Bid Addendum

Addendum No. 3 for the City of Staunton Johnson, Byers, and New Street Tunnel Repairs.

Addendum Date: November 10, 2025

CITY OF STAUNTON
JOHNSON, BYERS, AND NEW
STREET TUNNEL REPAIRS
STAUNTON, VIRGINIA

COMM NO:	240197
DATE:	10/06/2025
DRAWN: FAH	DESIGN: FAH
CHECK: WRM	
SHEET TITLE	
JOHNSON ST EXISTING CONDITIONS AND TUNNEL DEMOLITION	
SHT. NO. C-110	REV. NO. 1

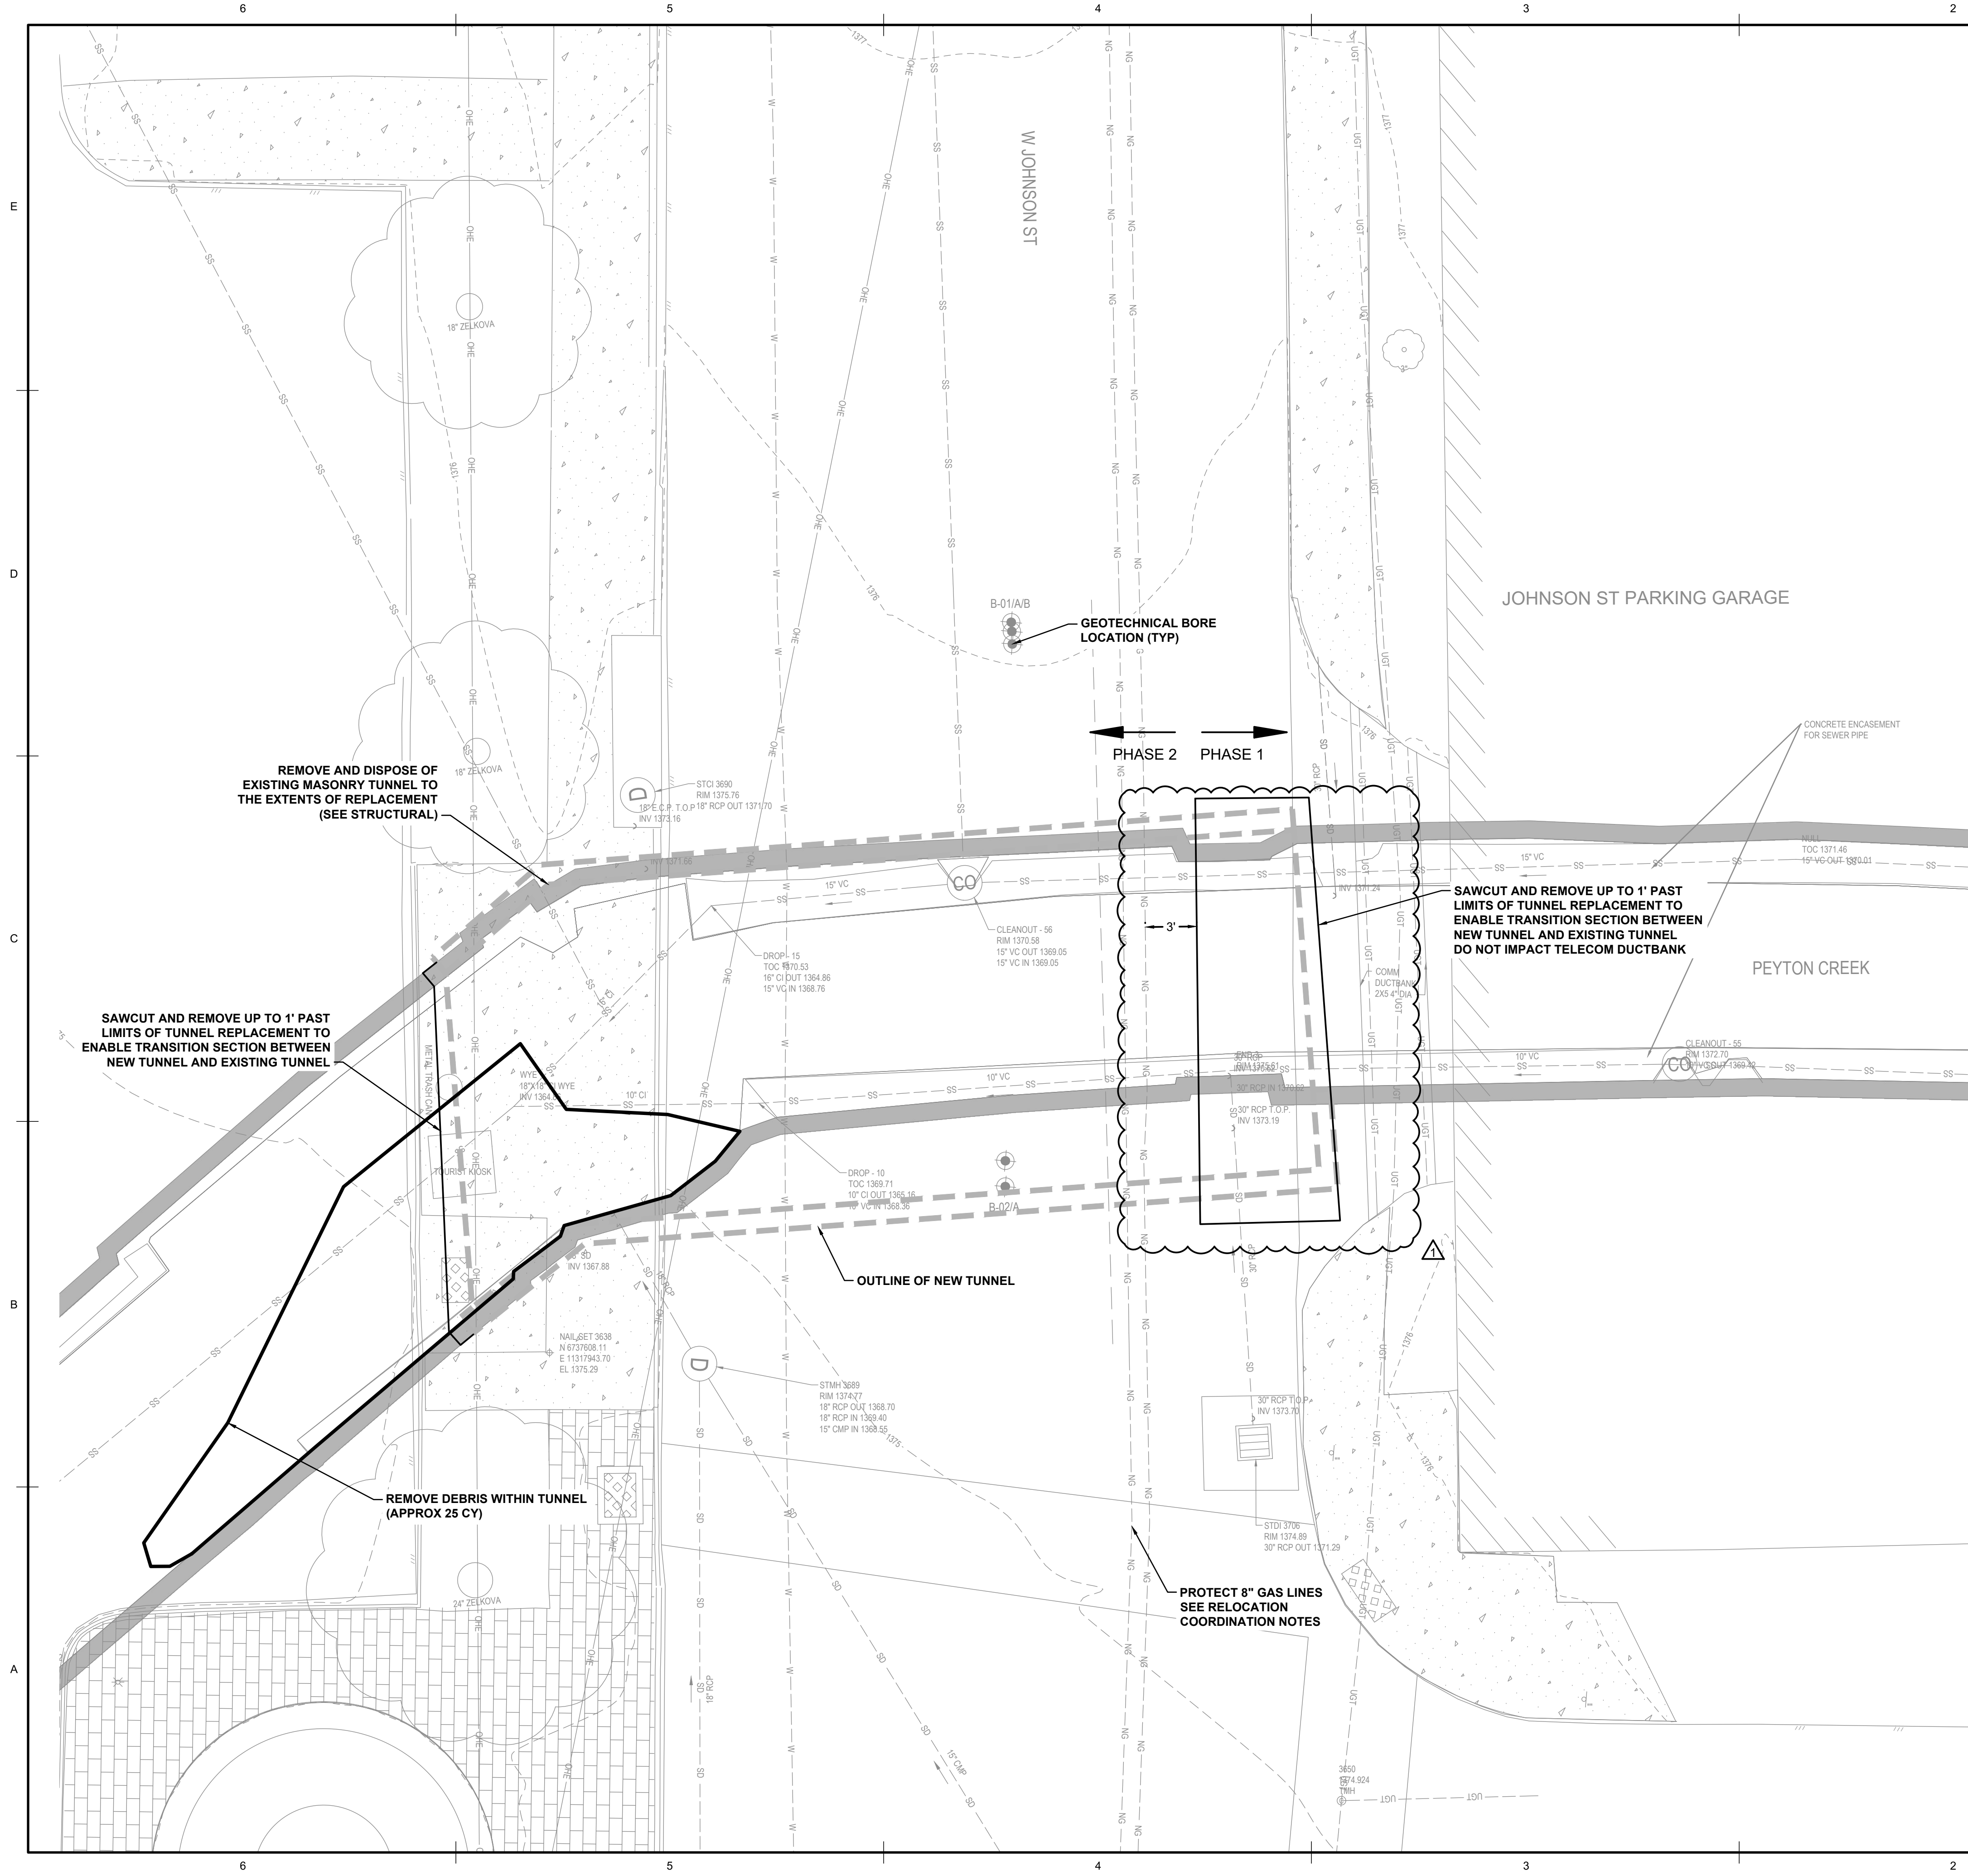
Drawing C-110 & C-111: Have been reissued to show the reduced demolition extents at the plan east end of the tunnel.

COMM NO: 240197	
DATE: 10/06/2025	
DRAWN: FAH	DESIGN: FAH
CHECK: WRM	
SHEET TITLE	
JOHNSON ST UTILITY DEMOLITION	
SHT. NO. C-111	REV. NO. 1

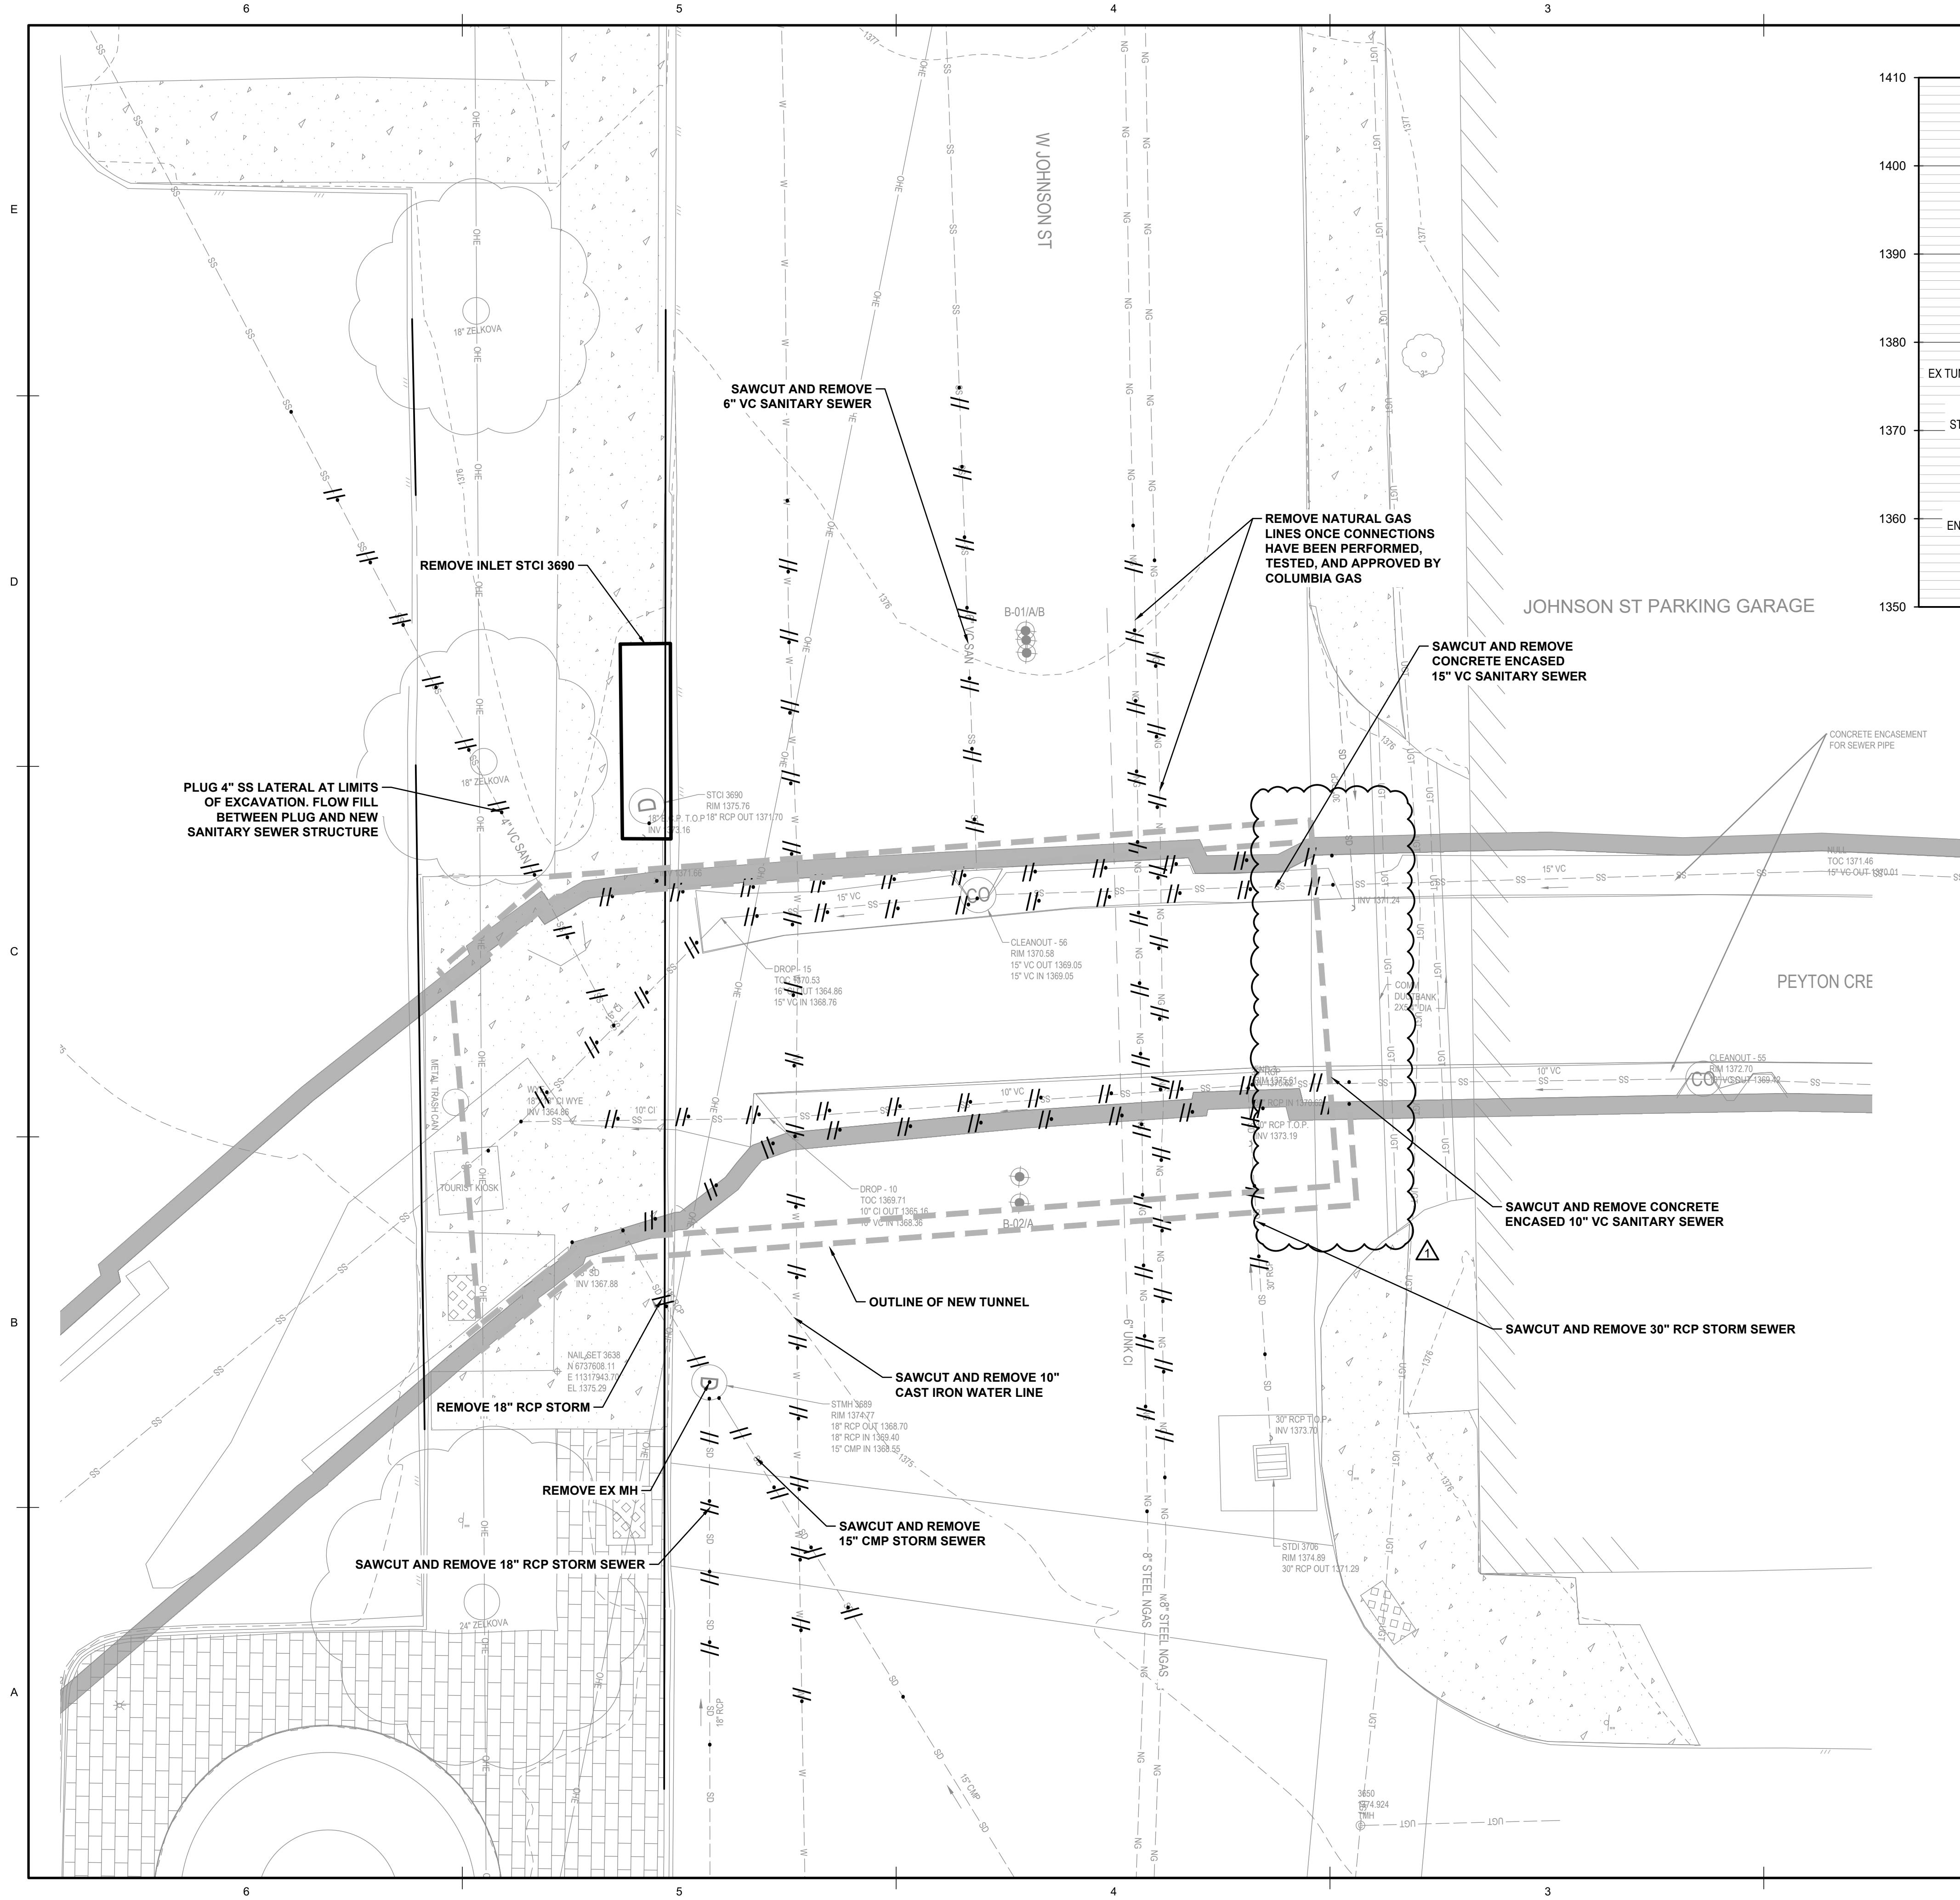
Question 32: Tunnel West Side detail (sheet C-111) appears to indicate the existing line is elevated above the stream bed and somehow attached to the existing tunnel wall. Pictures (requested above) would help clarify. Can a profile detail with elevation be provided? It appears a drop manhole will be required but there are numerous utility conflicts.

Response: See Sanitary Sewer Profile A and C on C-116 for the replacement sanitary sewers. CO-2 and CO-3 drop the flow and are detailed on C-503. The concrete encasement for the sanitary sewer and riser structures is detailed on sheet S-501, including attachment to the tunnel wall. The apparent water line and gas line conflicts on C-111 are also addressed in the plan on C-114 and profiles on C-116.

COMM NO:	240197
DATE:	10/06/2025
DRAWN: FAH	DESIGN: FAH
CHECK: WRM	
SHEET TITLE	
JOHNSON ST SURFACE DEMO	
SHT. NO.	REV. NO.
C-112	1

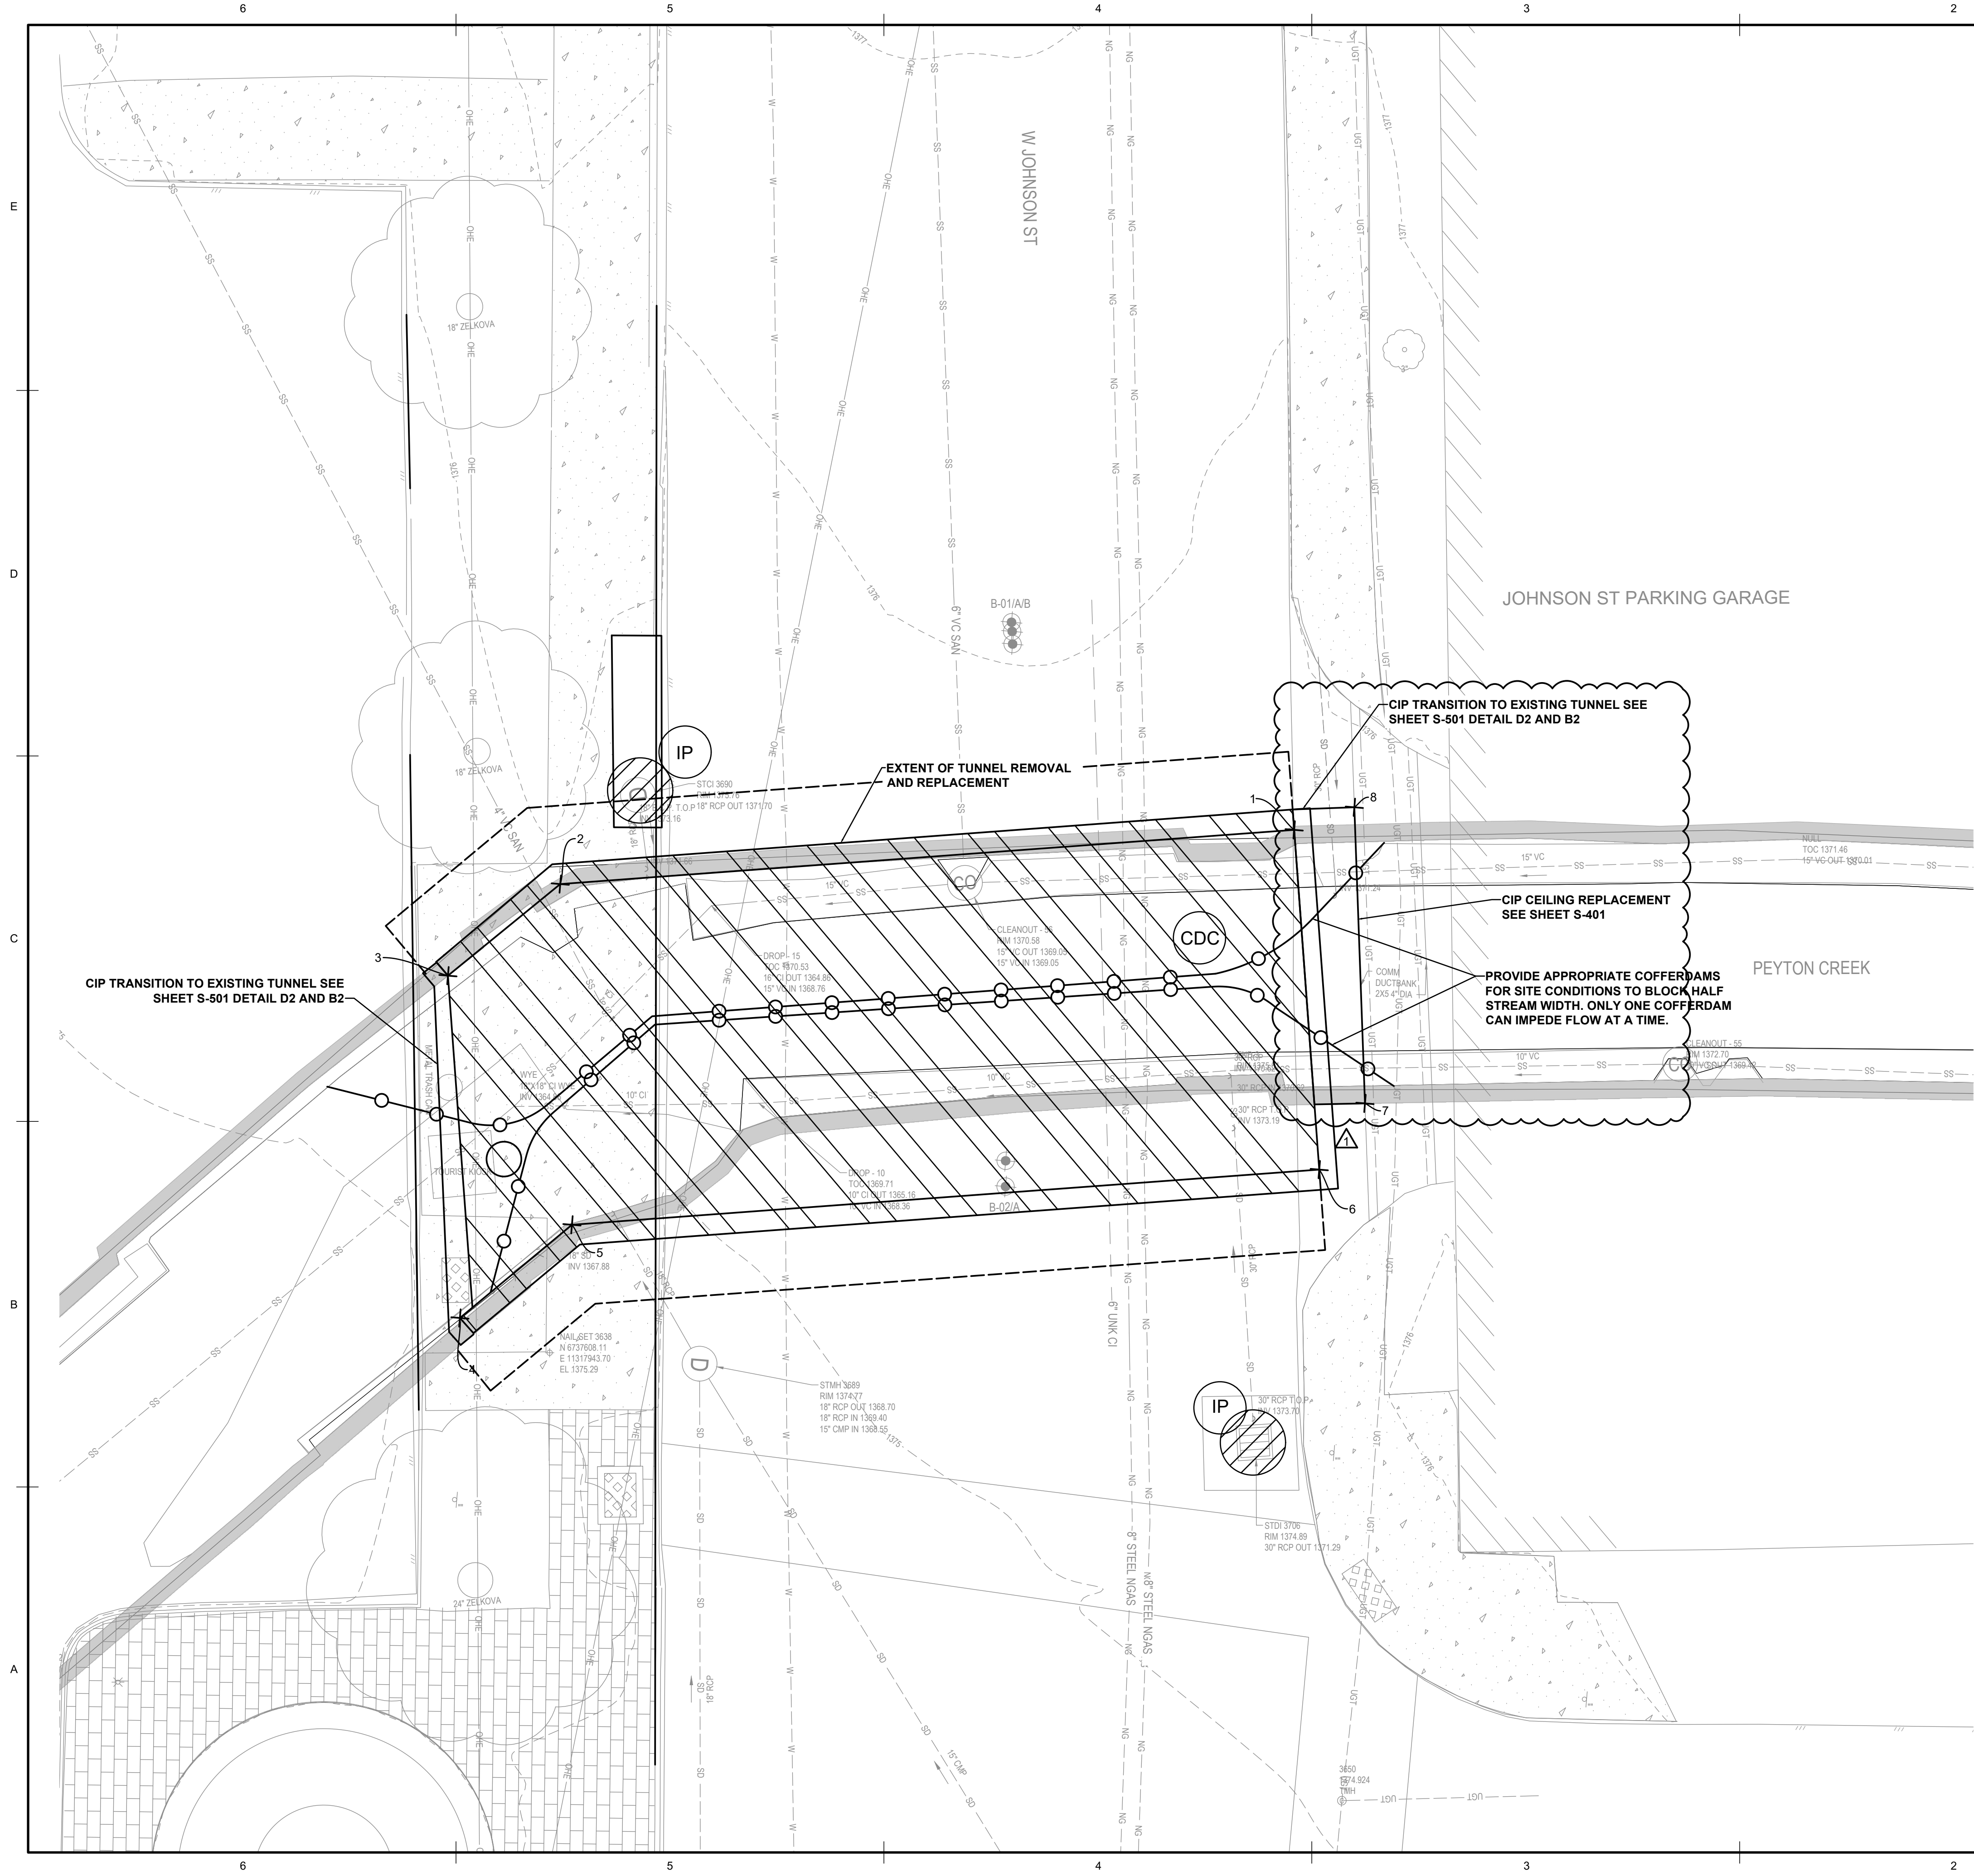
1. The contractor shall remove the trees indicated for removal on C-112 (revised in this Addendum) during the initial mobilization. Contractor shall coordinate tree removal with Dominion Energy.

Drawing C-112: Has been reissued to show the removal of all four Zelkova trees parallel to Johnson St, the section of ceiling only demo, and additional pavement removal.
